Executive Director's Recommendation

Commission Meeting: November 7, 2019

PROJECT Second Division Memorial Modification President's Park Constitution Avenue, NW & 17th Street, NW Washington, DC	NCPC FILE NUMBER 8120 NCPC MAP FILE NUMBER 1.31(73.10)45017
SUBMITTED BY United States Department of the Interior National Park Service	APPLICANT'S REQUEST Approval of comments on concept plans
REVIEW AUTHORITY Commemorative Works Act per 40 U.S.C. § 8905	PROPOSED ACTION Approve comments on concept plans ACTION ITEM TYPE Staff Presentation

Option B

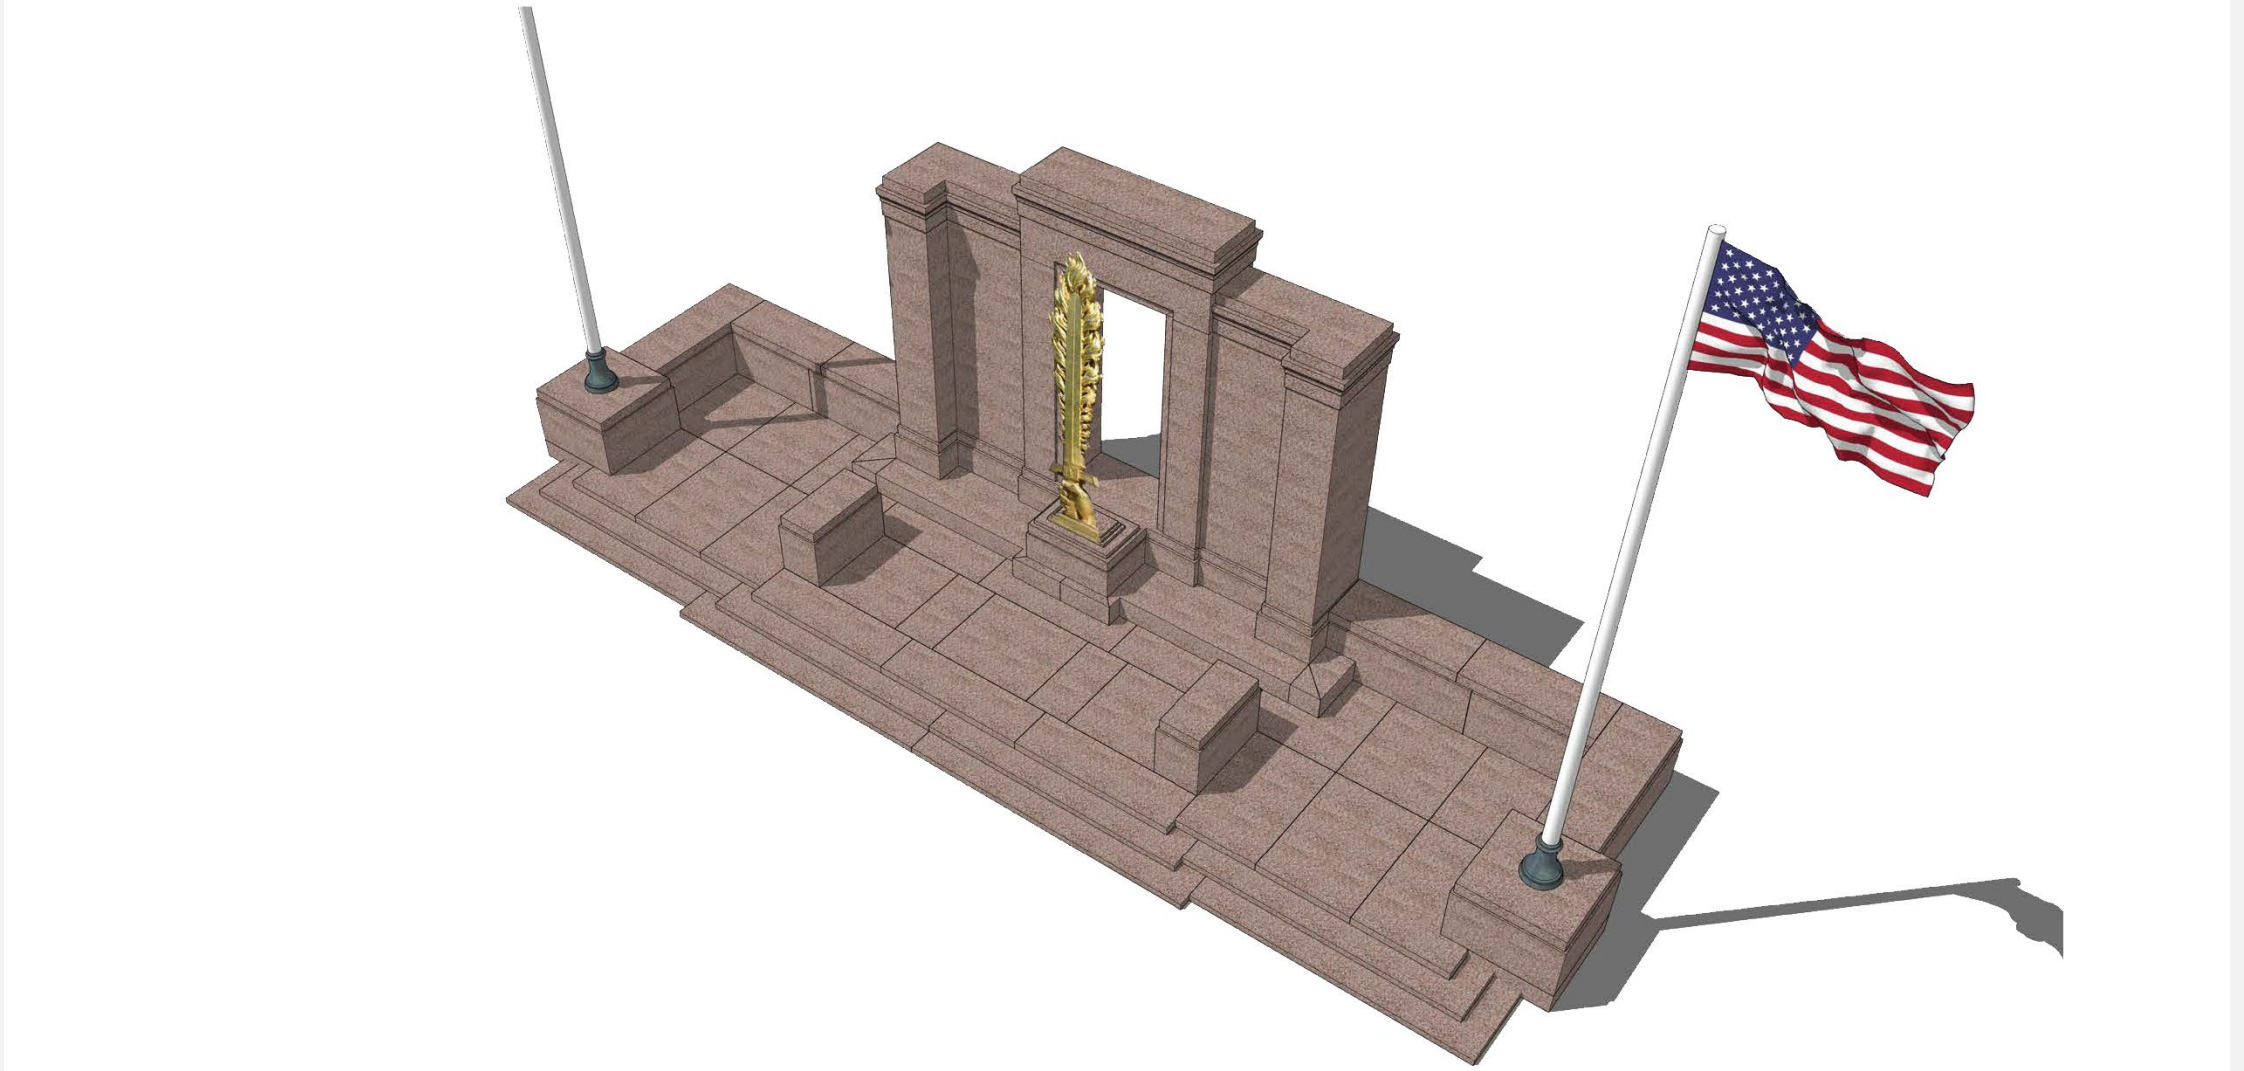
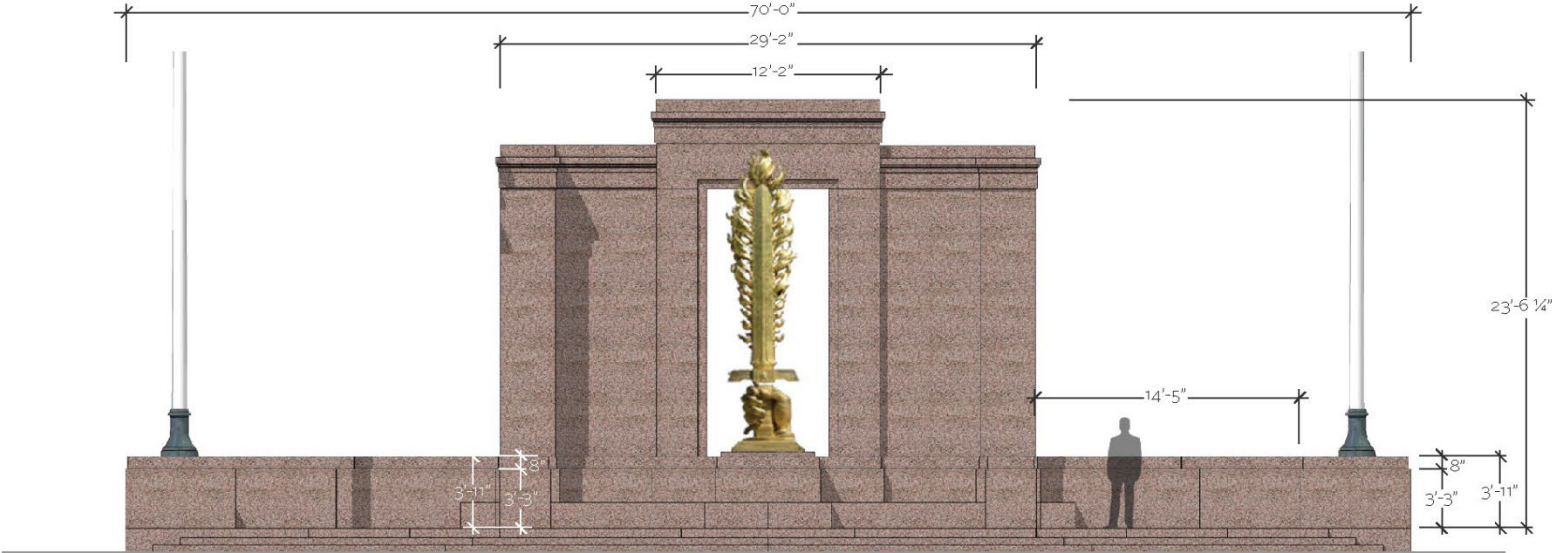
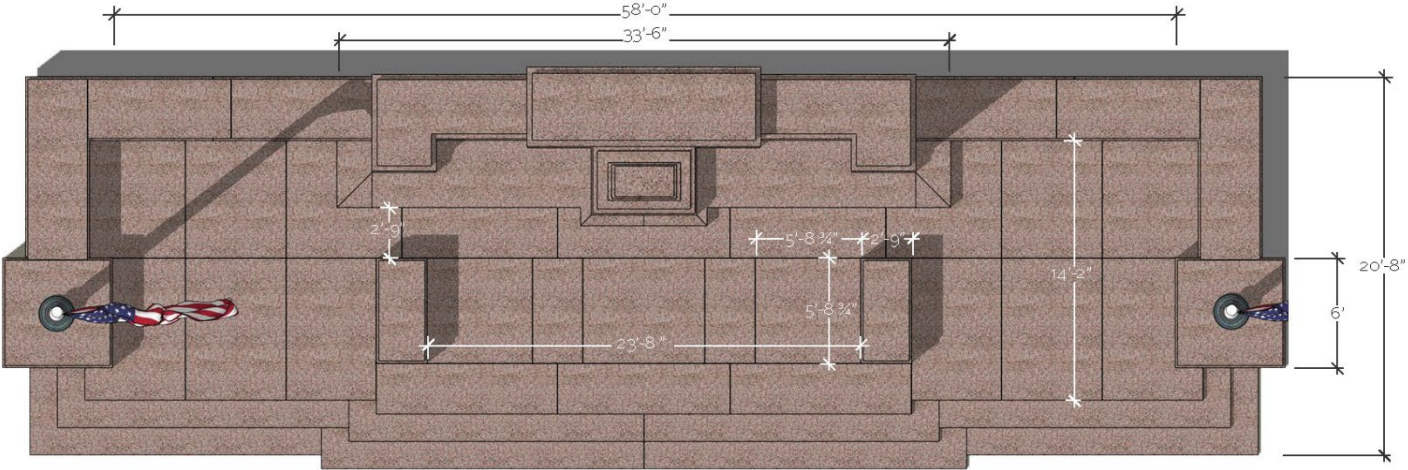
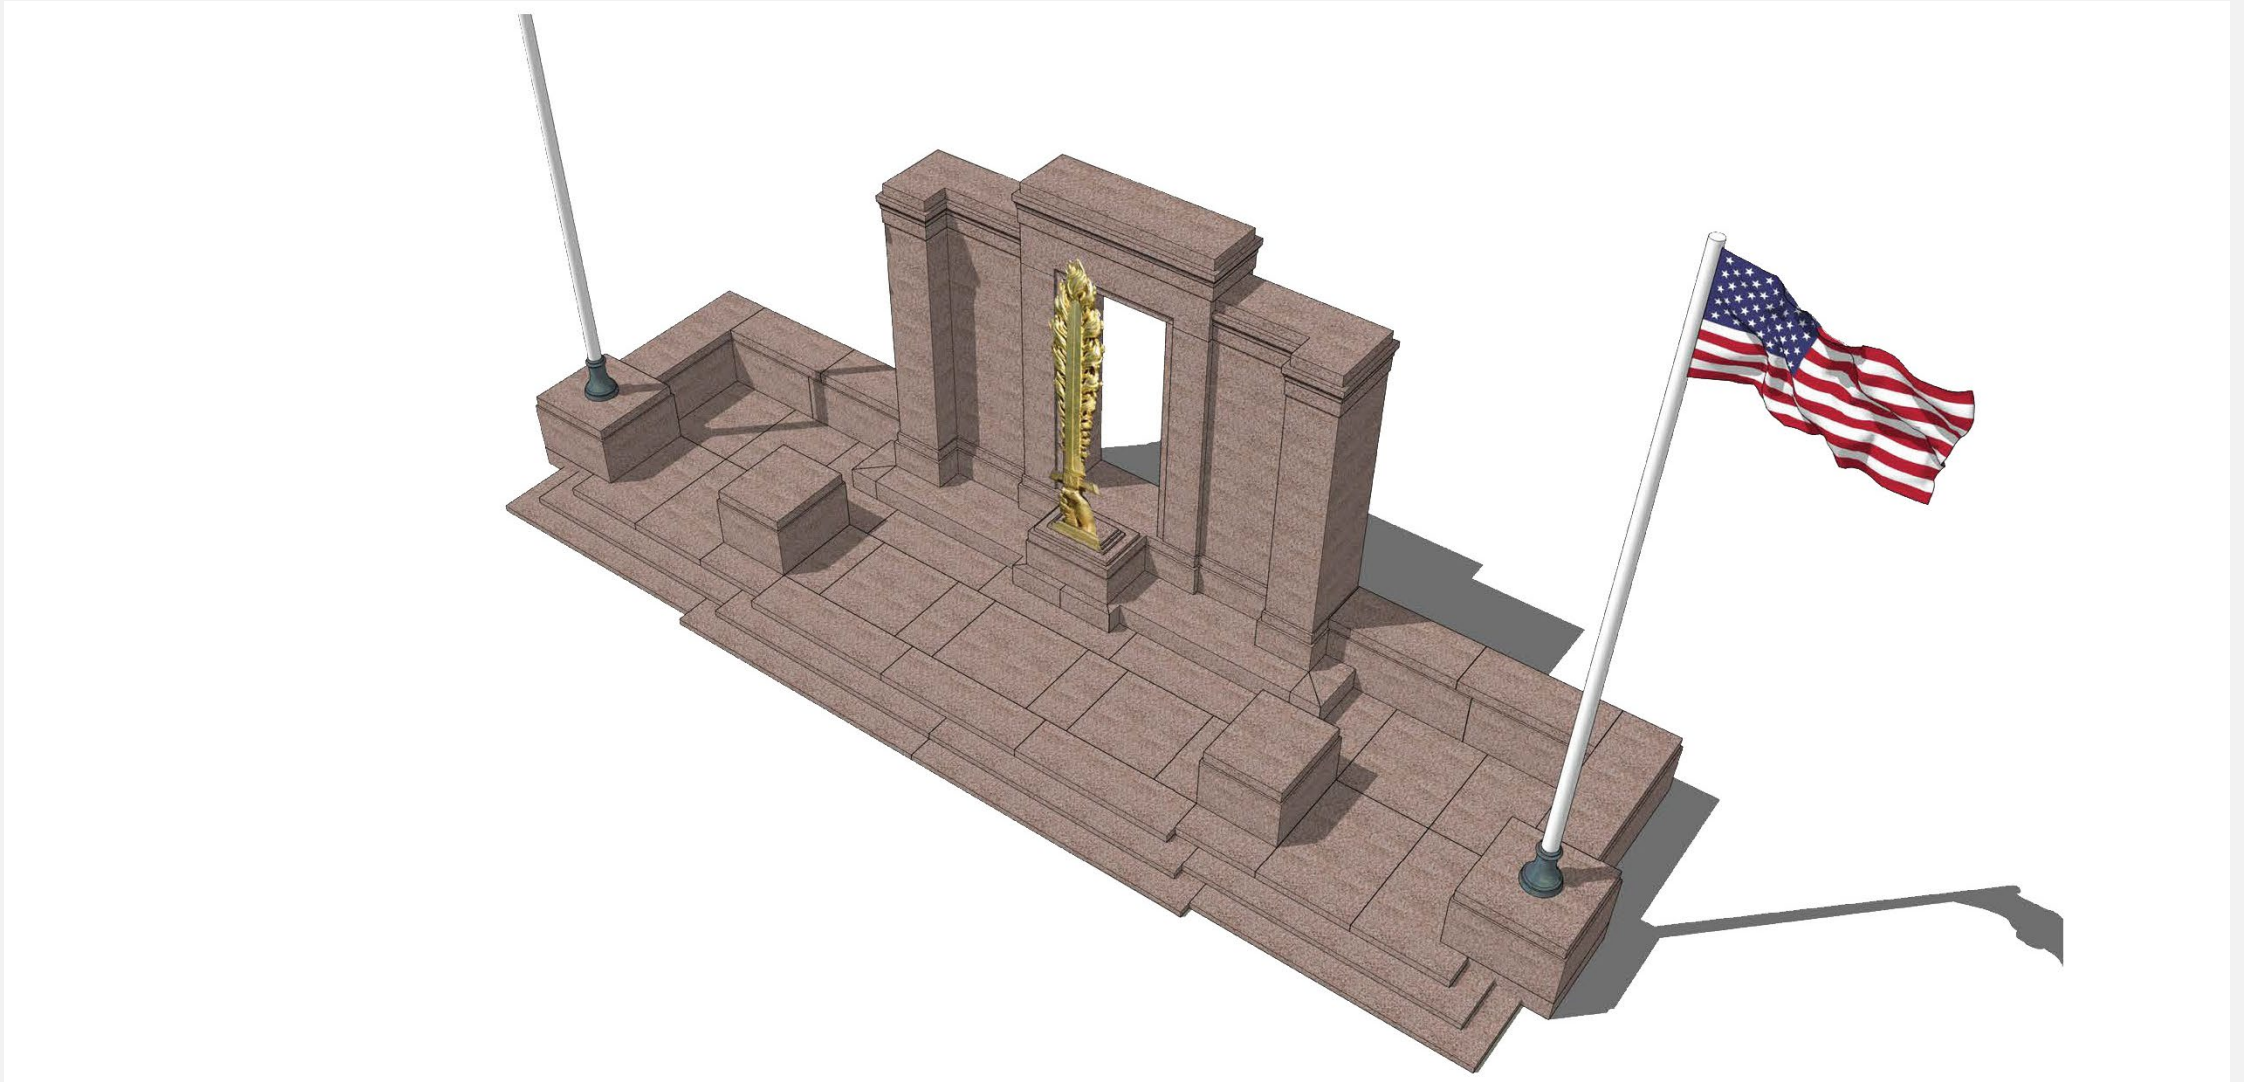
Finds Options A, B, and C do not alter the footprint of the memorial. Each includes the addition of two new stone plinths in varying sizes and locations. However, the locations of the new plinths

create “pinch points” for pedestrian circulation and do not allow sufficient space for gathering within the memorial platform. The original memorial elements would be altered in these options.

Options A, B, and C are similar in that they do not alter the footprint of the memorial. Each includes the addition of two new stone plinths in varying sizes and locations. However, the locations of the new plinths are concerning because they create "pinch points" for pedestrian circulation. The space between the plinths and existing memorial walls measures 2'-9". Typical routes for pedestrian movement should be greater than 3'-0". Further, the introduction of the new plinths into the existing memorial platform does not allow for sufficient space for gathering within the memorial itself.
